POINT BEACH NUCLEAR PLANT, UNIT NO. 1

AMENDMENT TO FACILITY OPERATING LICENSE

Amendment No. 165
License No. DPR-24

ATTACHMENT TO LICENSE AMENDMENT NOS. 165 AND 169
TO FACILITY OPERATING LICENSE NOS. DPR-24 AND DPR-27
DOCKET NOS. 50-266 AND 50-301

Figure 15.2.1-2
REACTOR CORE SAFETY LIMITS
POINT BEACH UNIT 2

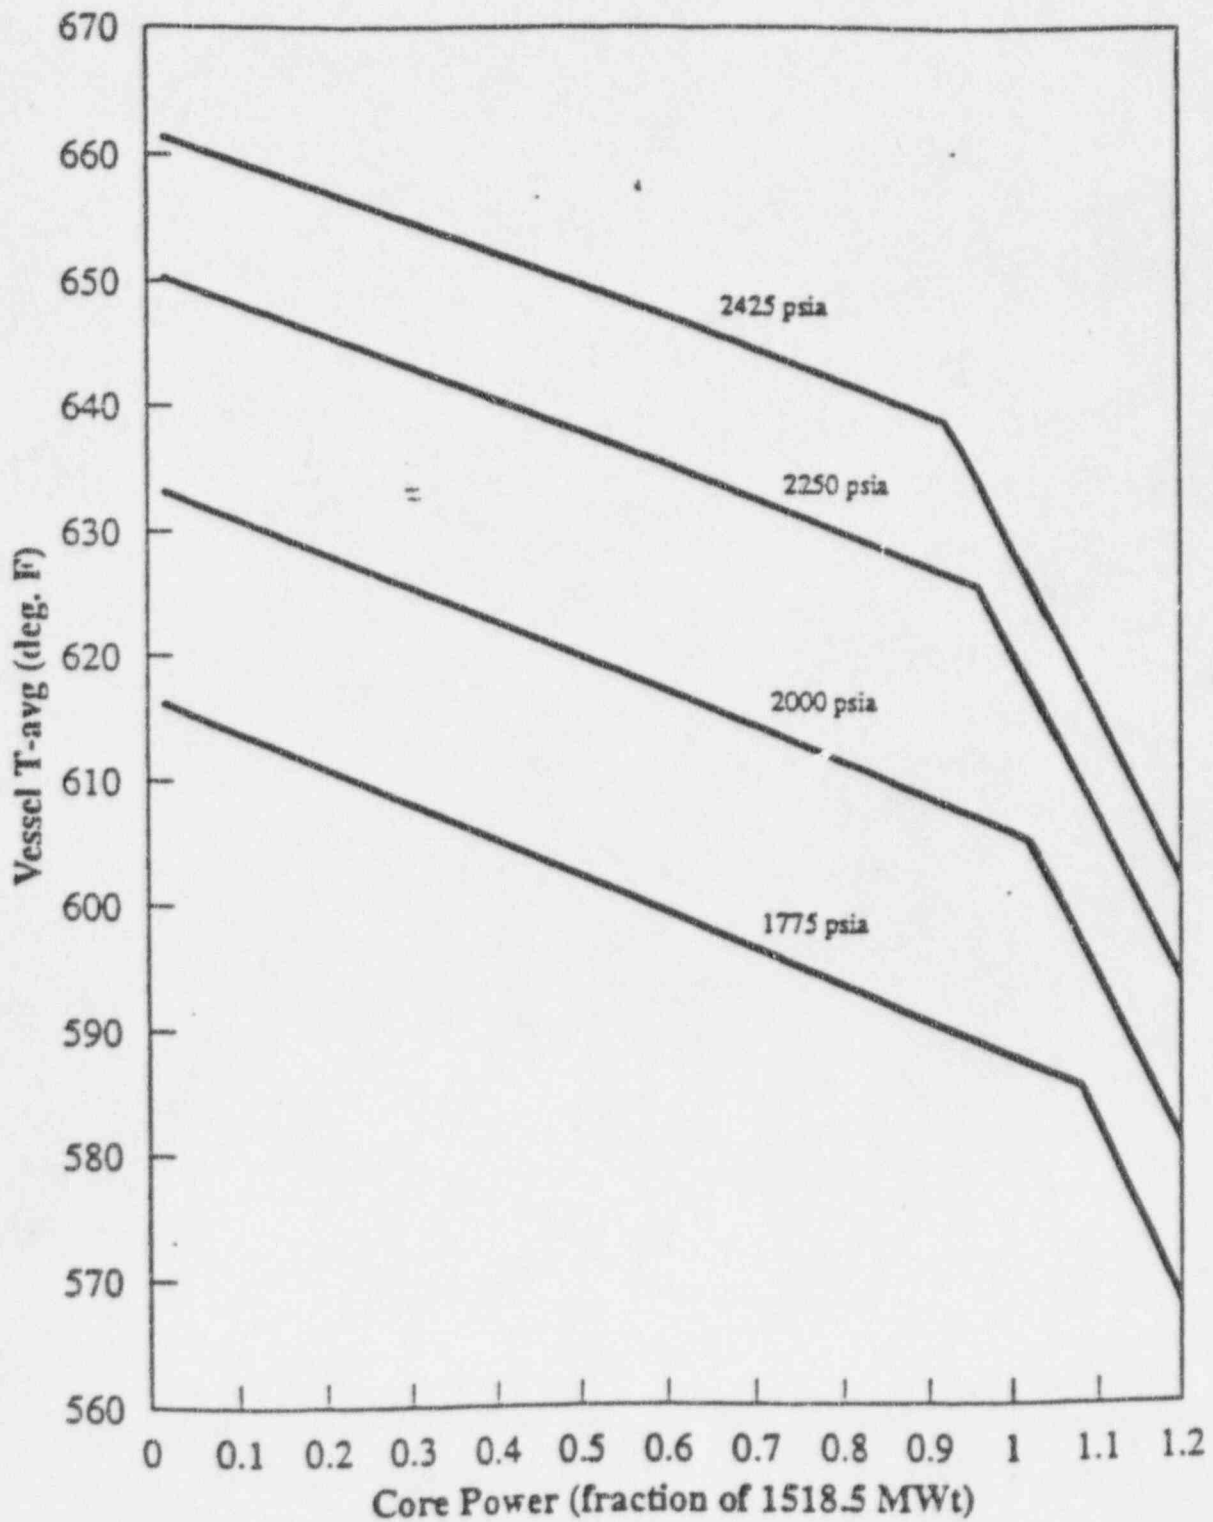
Revise Appendix A Technical Specifications by removing the pages identified below and inserting the enclosed pages. The revised pages are identified by amendment number and contain marginal lines indicating the area of change.

TS 15.1-4
TS Figure 15.2.1-2
TS 15.3.1-19

TS 15.1-4
TS Figure 15.2.1-2
TS 15.3.1-19
